ADDENDUM

Project Name:	Kosciuszko Middle School Toilet Room Upgrades	Addendum No:	One (1)
Project Number:	16-118	Issue Date:	April 29, 2016
Project Location:	Hamtramck, Michigan

To the Contract Documents for the requested Kosciuszko Middle School Toilet Room Upgrades

A4-01

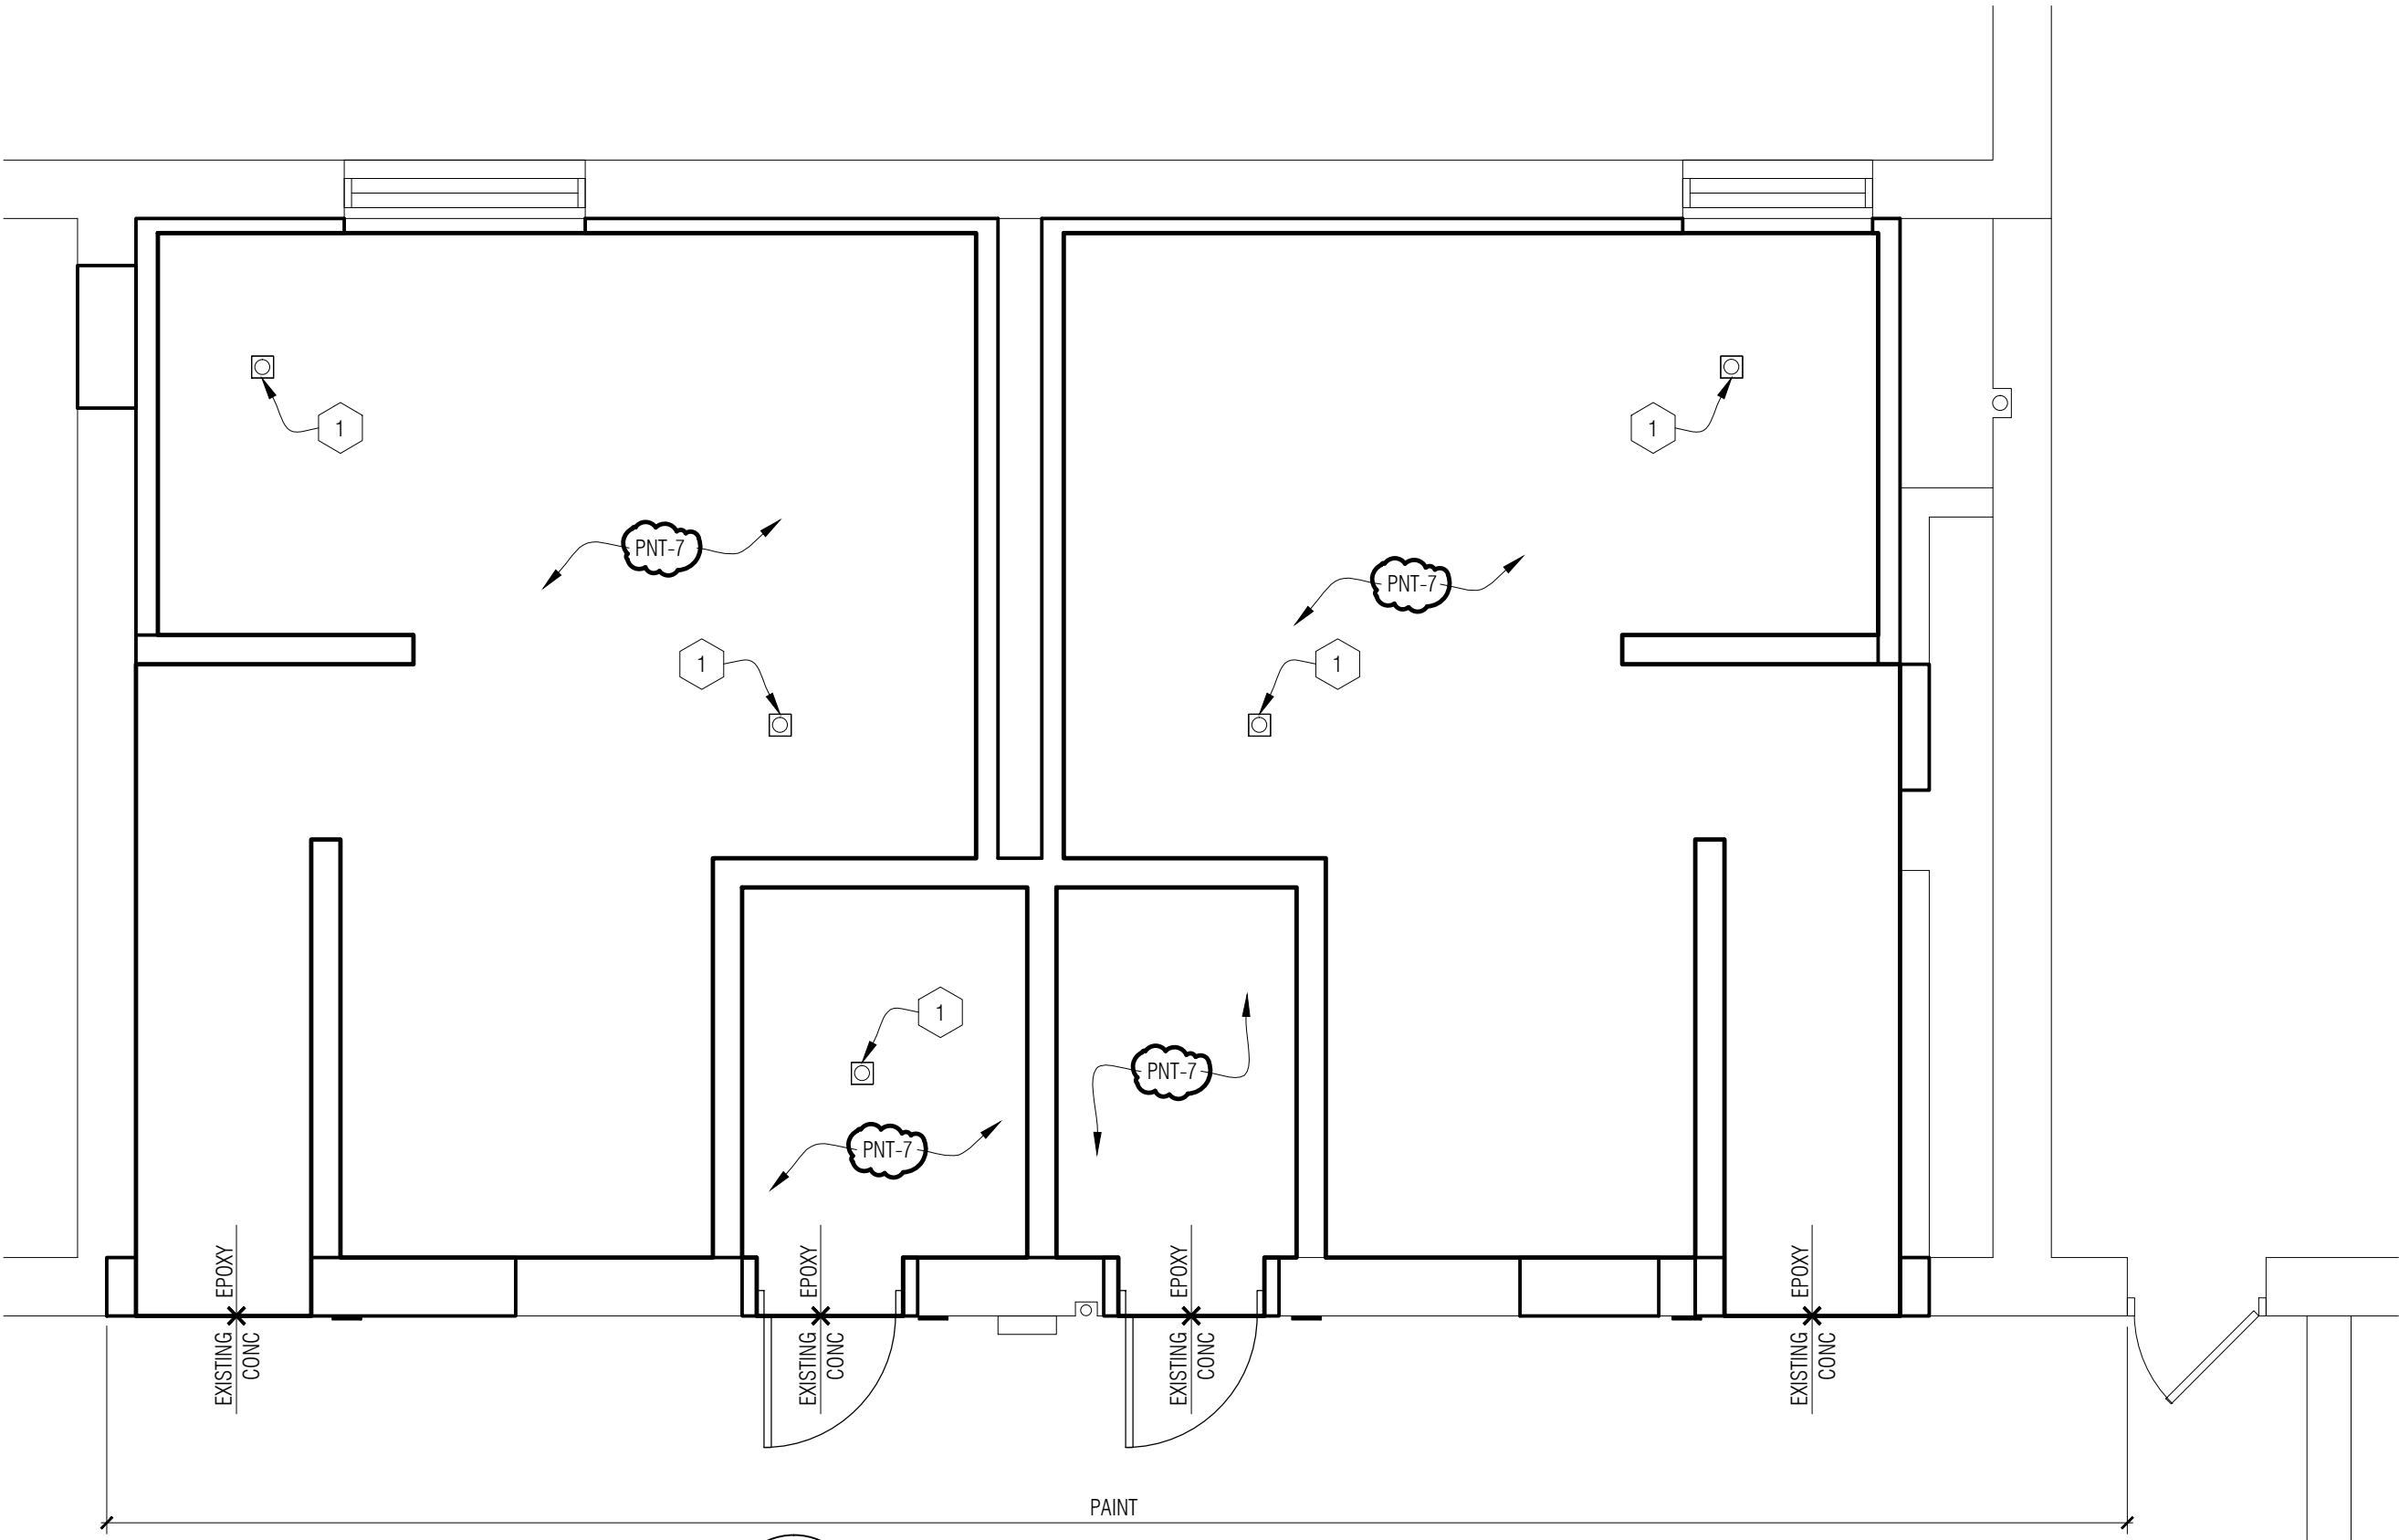
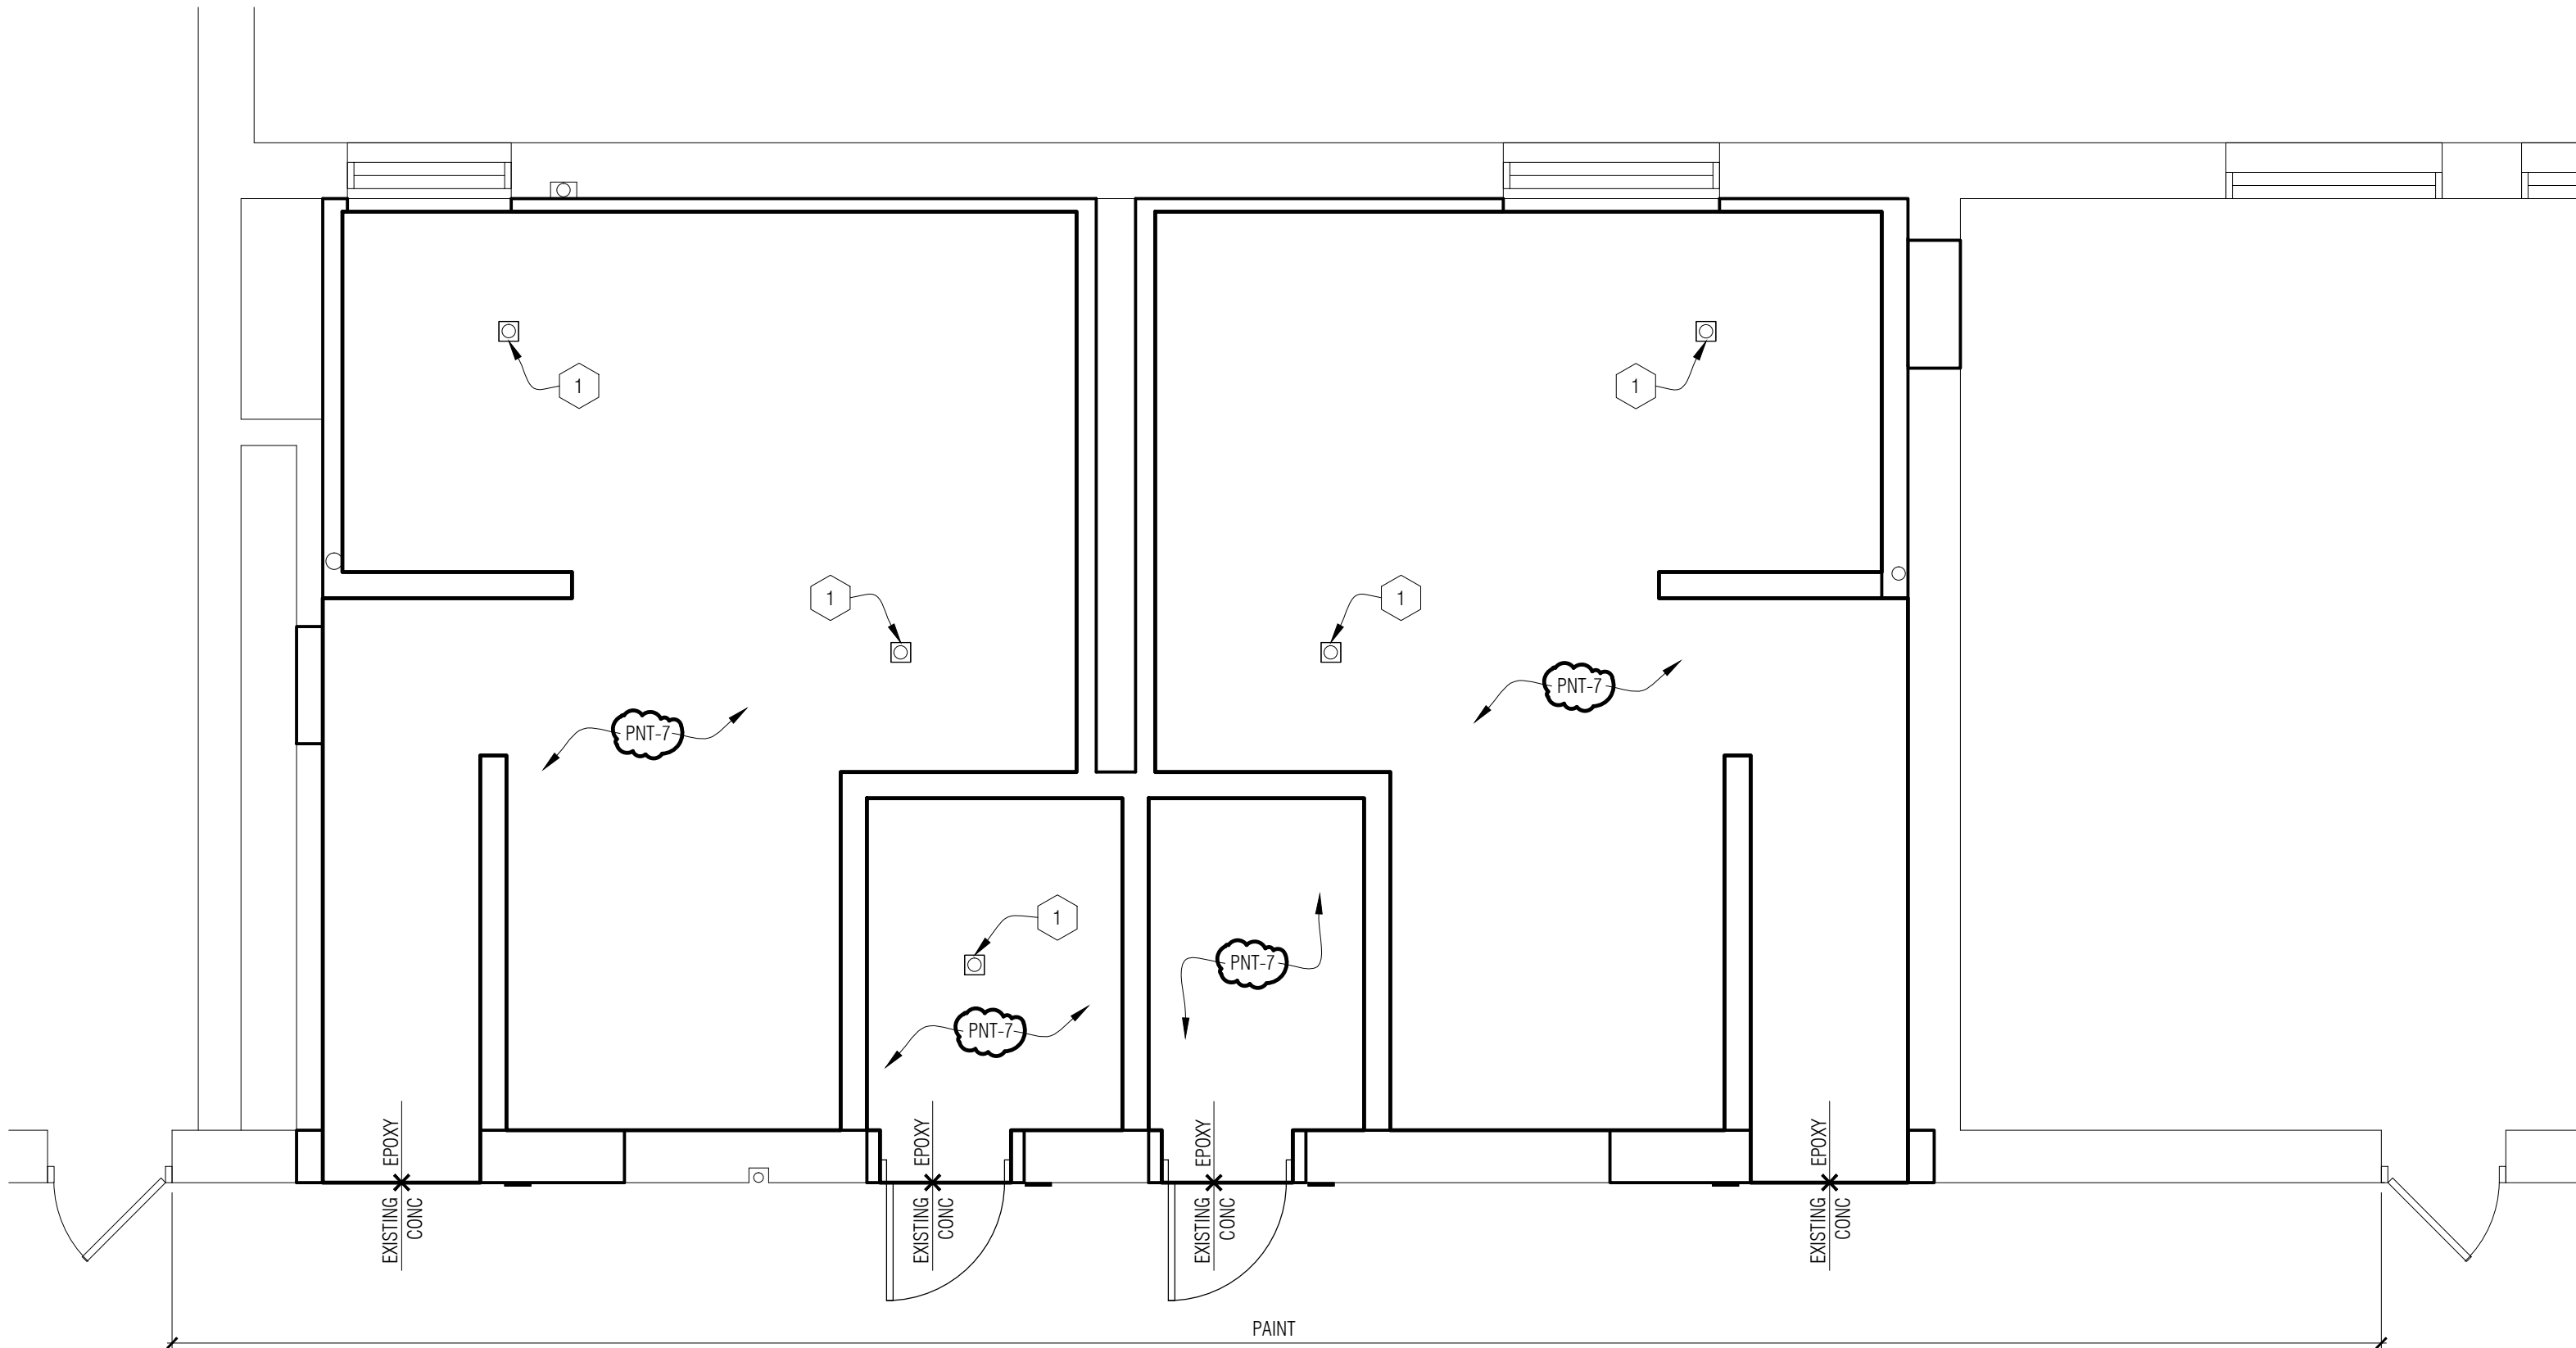
Item A3 Drawing A4-01; Partial Reflected Ceiling Plans (revised and reissued this Addendum)
A. Revised ceiling plans as indicated

A9-01

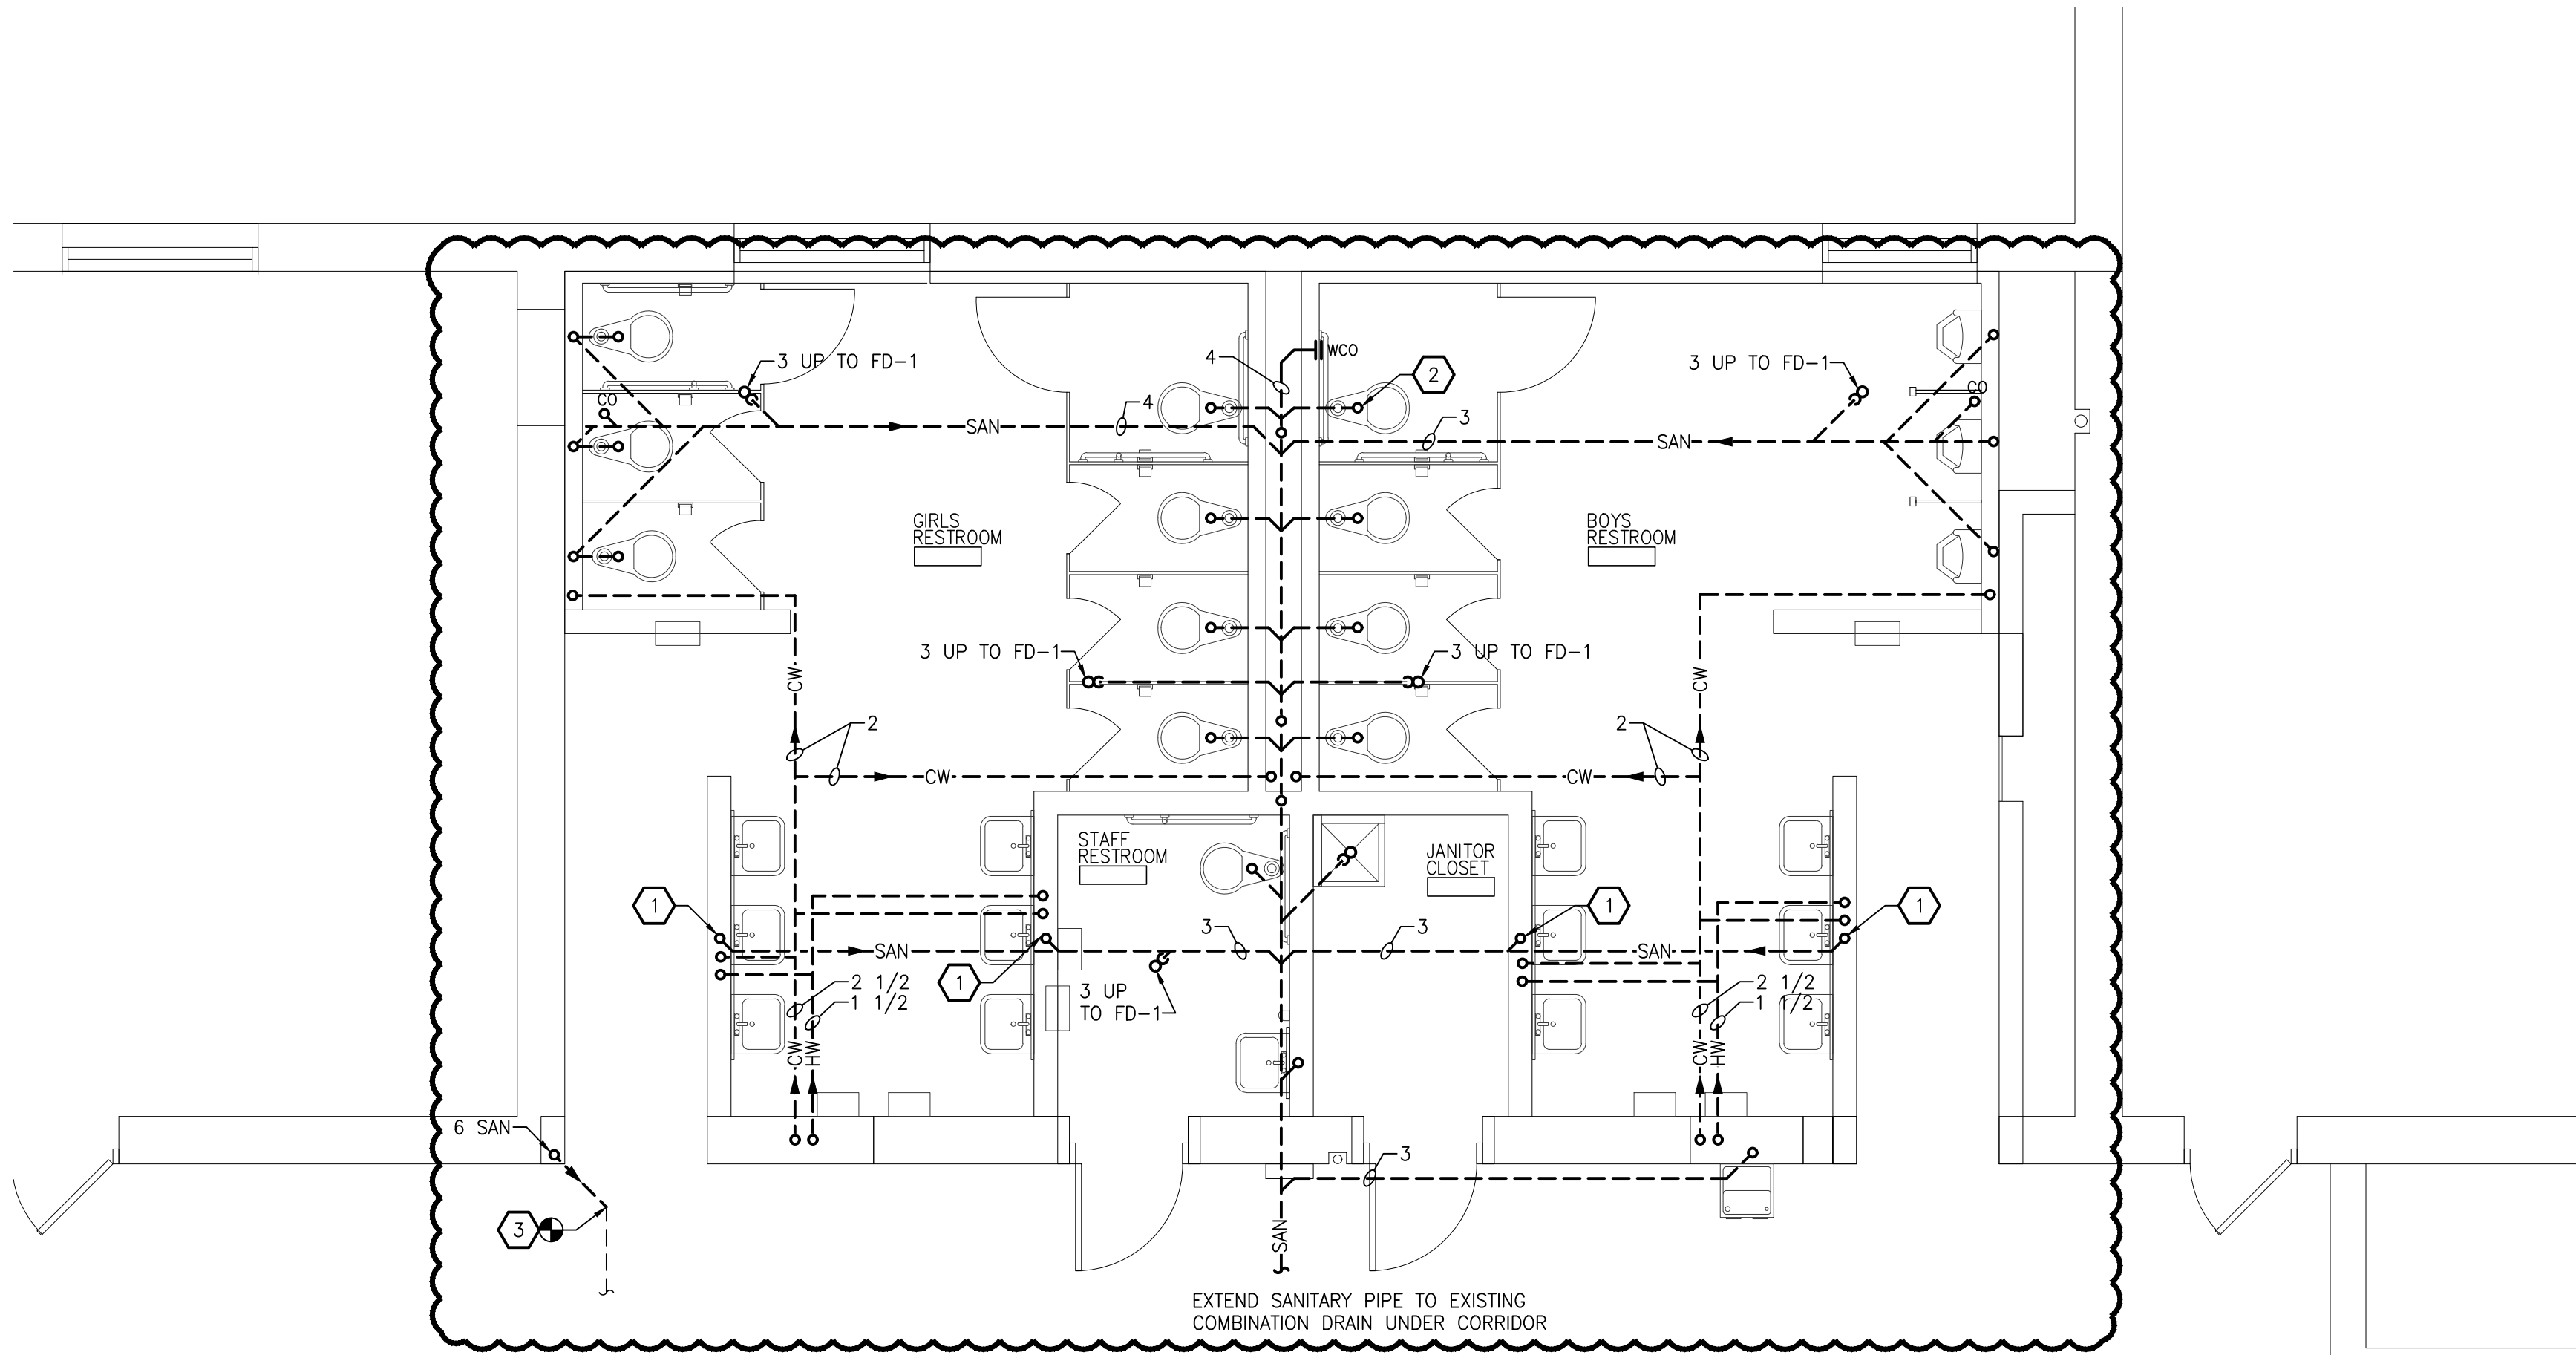
Item A4 Drawing A9-01; Partial Reflected Ceiling Plans (revised and reissued this Addendum)
A. Revised finish floor plans as indicated
